# Service Bulletin

Bulletin No.: 18-NA-136

**Subject:** Rattle, Loose Lumber Type Noise or Popping/Clunking Type Noise Coming from Rear Suspension

5046813

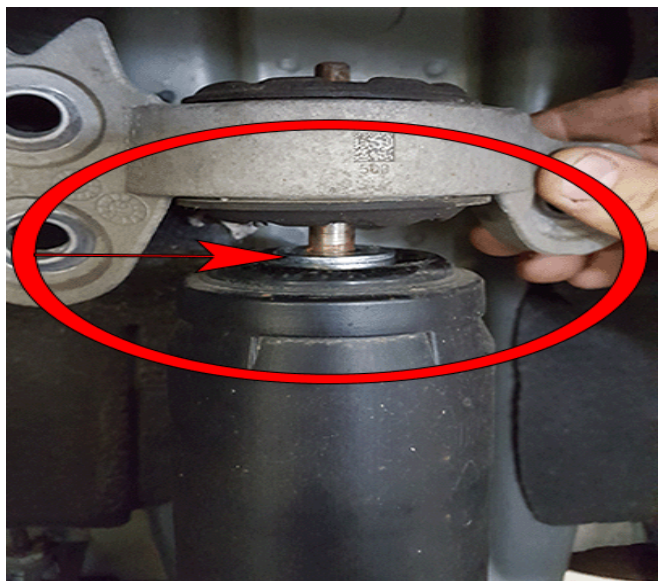
**Note:** This will prevent contact of the shock to the rubber of the shock mount.

5. Install a washer on the rear shock absorber as shown above.
6. Reinstall the shock into the shock mount and tighten the nut.

Tighten the nut to 20 N•m (15 lb ft).
